Subject: Red Mountain Underground Gold Project -
Responses to the Canadian Environmental Assessment Agency's Information
Request #1

Prepared for: Andrea Raska, Project Manager, Pacific and Yukon Region, Canadian Environmental
Assessment Agency

Prepared by: IDM Mining Ltd.

Date: January 16, 2018

Figure 8-1: Simulated Transient Groundwater Recharge Profile

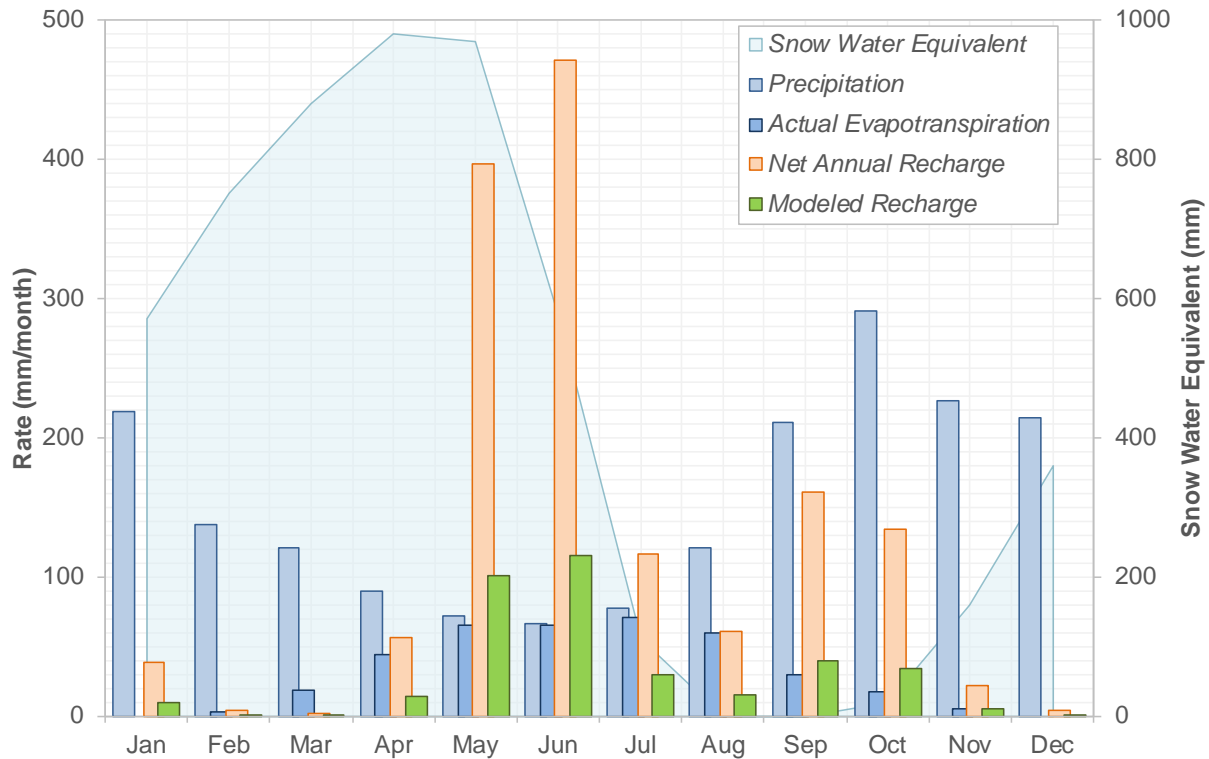
- It appears that the recharge imposed/assumed in the model (for transient scenarios) is earlier in the year than field data would suggest. The EIS (Appendix 10-A, section 6.4.4) states: “The [net available recharge] estimates suggest the peak of recharge occurs between May and June as a result of freshet melt”. However, Figure 14 shows that groundwater levels peak around August, and Figures 23 and 24 shows that baseflows obtained from stream hydrographs peak around July. In addition, Table 1 of Appendix G shows that temperatures typically do not rise above zero until June.

- The modeled recharge values represent only the recharge to the groundwater system; the near-surface runoff is not simulated by the groundwater numerical model. The modeled recharge values represent a fraction of the NAR (about 37% of NAR, or 29.4% of MAP). Figure 8-1 below provides an amendment to Figure 29 in Appendix 10-A to show the differences between NAR and modeled recharge.
